LOCA at 11th and Belmont The Goat Blocks

Design Review Submittal (LU# 14-125908 DZM AD) (DAR# 13-224797) (Pre-Application# EA-203772)

PRESENTED BY: KILLIAN PACIFIC OWNER: BELMONT INVESTMENT, LLC ARCHITECT: ANKROM MOISAN ARCHITECTS 06.30.2014

Design Updates- North Block Grocery Building

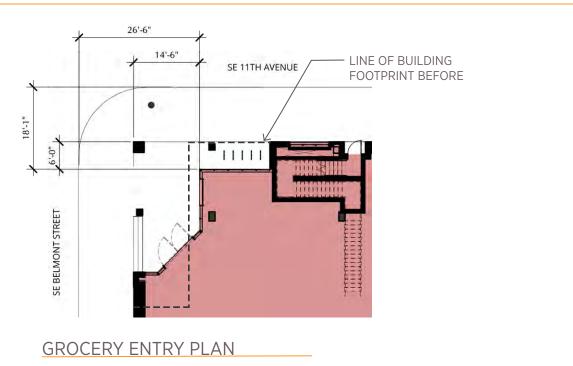
- 1. Design Concepts
- Explain design concepts of building
- 2. Material Palette
- Simply, too many materials
- Corten Steel not appropriate
- 3. 11th and Belmont Grocery entry
- Too small
- More bike parking
- 4. Belmont elevation
- Add more glazing to meet requirements
- RACC involvement Unclear
- 5. Exterior screens at upper housing floors to narrow and guestioned horizontal orientation
- 6. Transom Windows above bays scale is wrong
- 7. Hooded exhaust venting not well integrated.

Arriscraft Masonry changed to Brick to simplify material palette

Area for retail spill out increased, Depth of recess increased 1.5' to 14.5'

Brick detailed

Larger scale opening at corner to express entry, Simplifies building form.

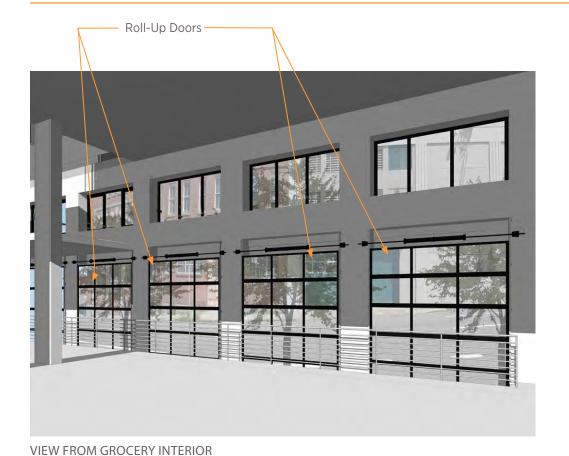
- 1. Design Concepts
- Explain design concepts of building
- 2. Material Palette
- Simply, too many materials
- Corten Steel not appropriate
- 3. 11th and Belmont Grocery entry
- Too small
- More bike parking
- 4. Belmont elevation
- Add more glazing to meet requirements
- RACC involvement Unclear
- 5. Exterior screens at upper housing floors to narrow and questioned horizontal orientation
- 6. Transom Windows above bays scale is wrong
- 7. Hooded exhaust venting not well integrated.

Fixed windows at these bays deleted

RACC art panels removed

Transom windows widened and integrated with bay below

Roll-up doors added at all bays

Glazing area increased to meet ground floor window requirements

Rills extended down to step with sidewalk grade

Bays recessed to create seating along sidewalk

Design Updates - Retail Building

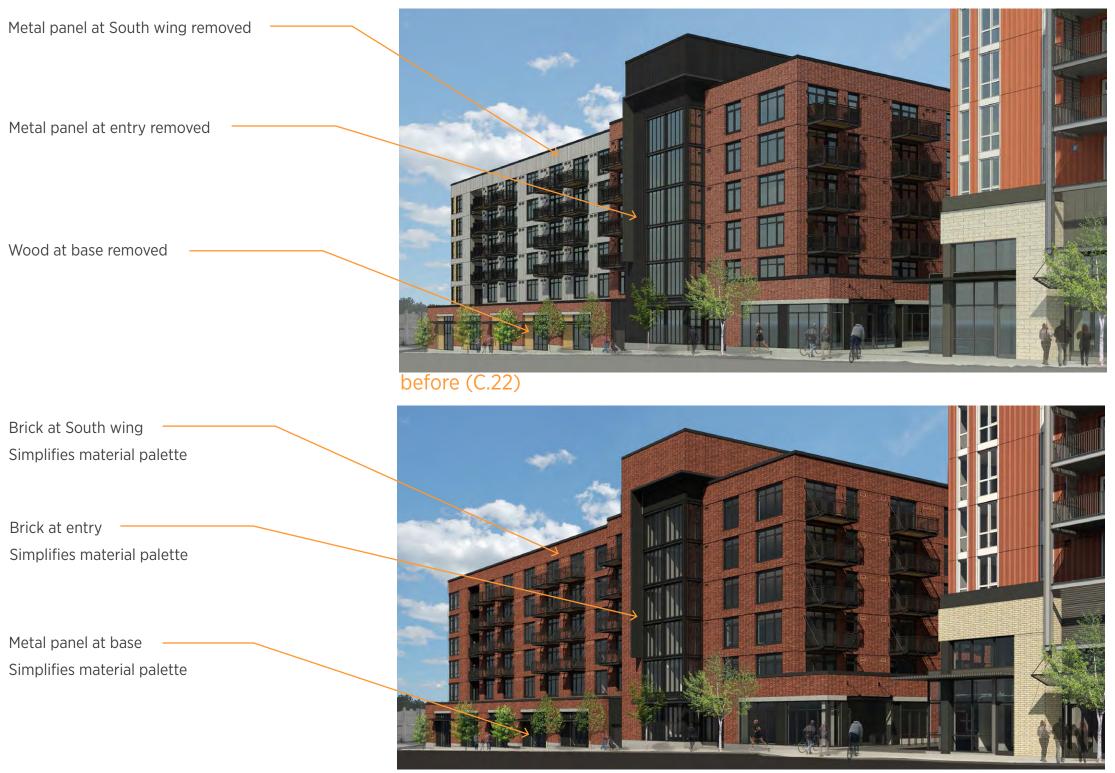
- Explain design concept of building
- 2. Material Palette
- Simplify, too many materials
- Wood cladding seems unnecessary
- Glass canopies, hard to keep clean
- 3. Garden center
- Integrate or fully detach
- 4. Signage truss is confusing without signage

Trellis and retail at South end removed

Step in roof parapet removed

Increased area for public plaza space

Simplified roof line
